Minutes
of
112th PCC Meeting

EASTERN REGIONAL POWER COMMITTEE

MINUTES OF 112th PROTECTION COORDINATION SUB-COMMITTEE MEETING HELD ON 11.03.2022 AT 10:30 HOURS

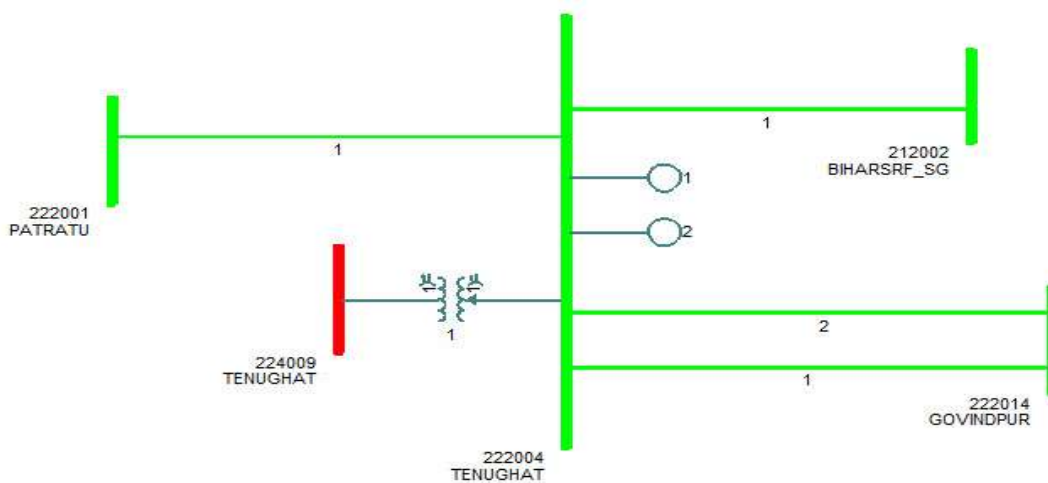
Powergrid representative informed that relay at their end for all four circuits of Jayanagar- PGCIL line sensed the fault in zone 3 and got tripped. However, Y phase circuit breaker for 220 kV Jeypore-Jaynagar-3 did not get open due to issue with trip coil which led to operation of LBB relay and subsequently 220 kV Main Bus-1 at Jeypore (PG) got tripped.

PCC advised OPTCL to restore LBB/bus bar protection at 220 kV Jayanagar S/s at the earliest and till the timethe busbar protection is put back into service, the zone-4 time settings of all 220 kV feeders may to be reduced 250 msec.

OPTCL was also advised to review resistive reach settings as per the guidelines finalized in 100th PCC meeting.

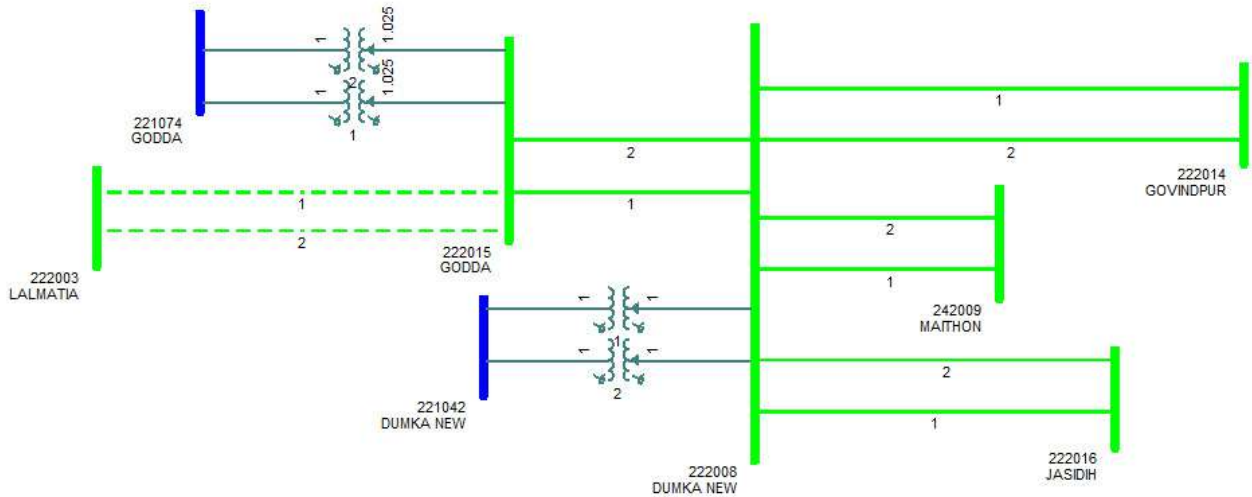
TVNL representative stated that no physical fault was found within the 220 kV Tenughat switchyard.

After detailed deliberation, PCC advised TVNL to revise the unit overcurrent settings immediately. Regarding nonoperation of busbar protection, TVNL was advised to test the busbar relay at the earliest & the report may be submitted to ERPC/ERLDC.

Categorization of tripping without any fault

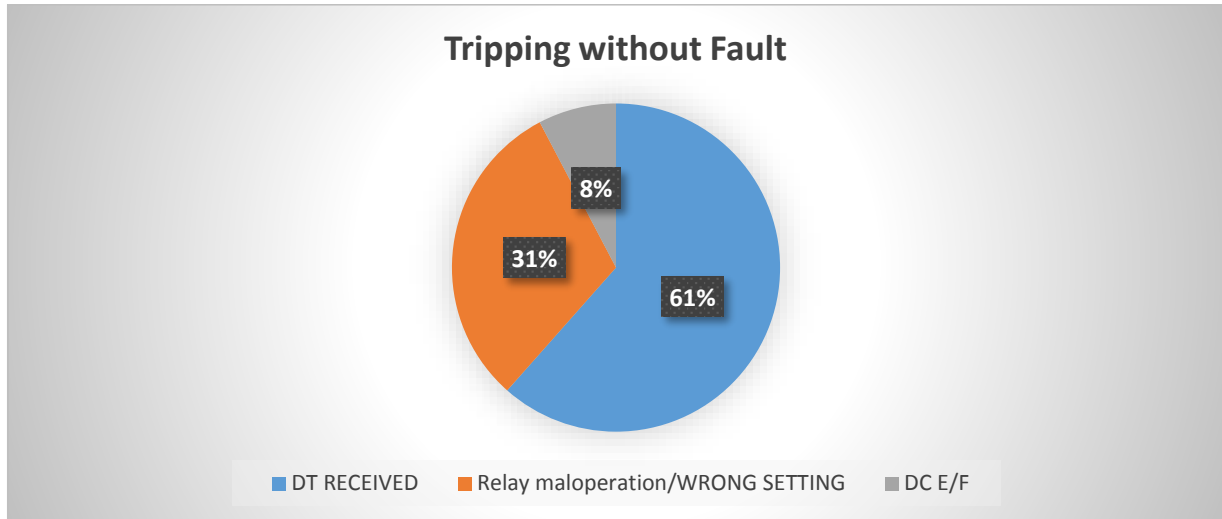
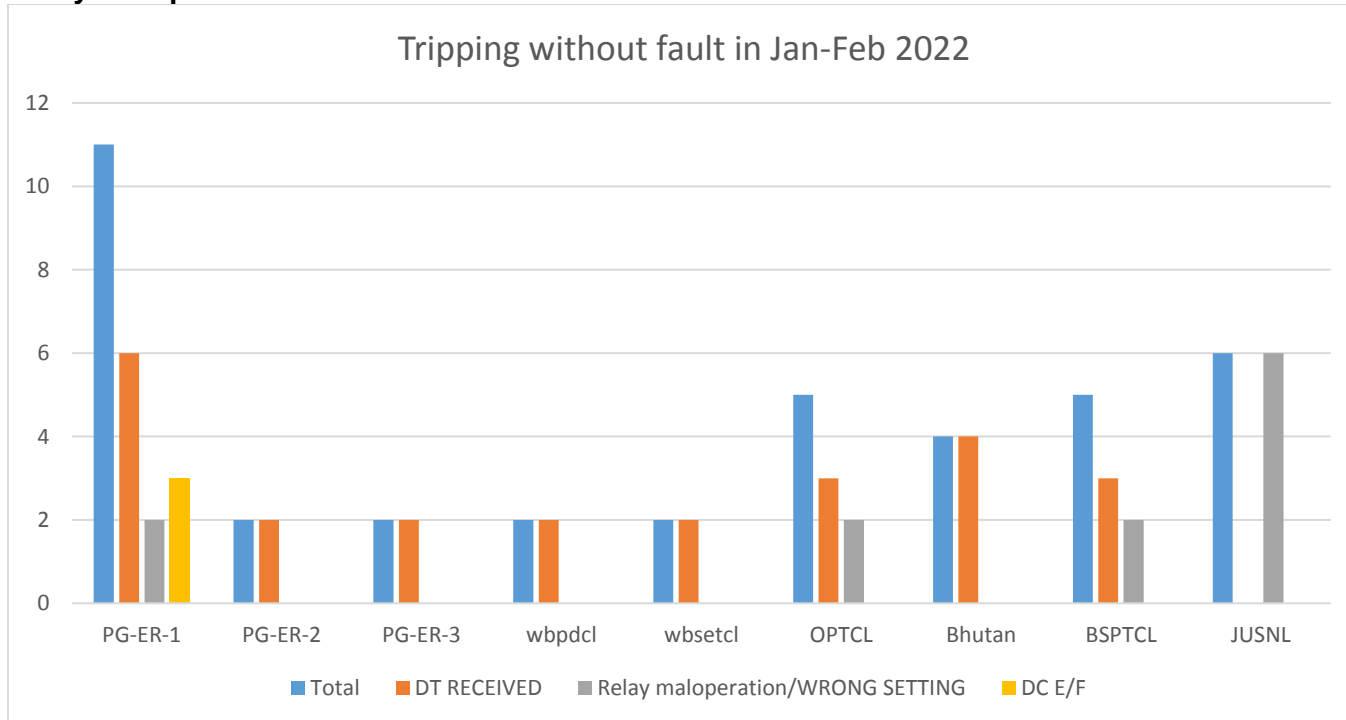
ERLDC representative informed that almost 44% of line tripping in last two months in ER grid had occurred without any fault in the line. He pointed out that most of tripping had occurred on account of DT receipt.

PCC expressed concern over the spurious tripping of the transmission lines without any fault in the line and opined that this would adversely impacting reliability & security of the grid.

PCC advised all the utilities to take appropriate measure in finding out the reason behind spurious tripping of line and to rectify it as soon as possible so that the undesirable tripping of lines can be eliminated.
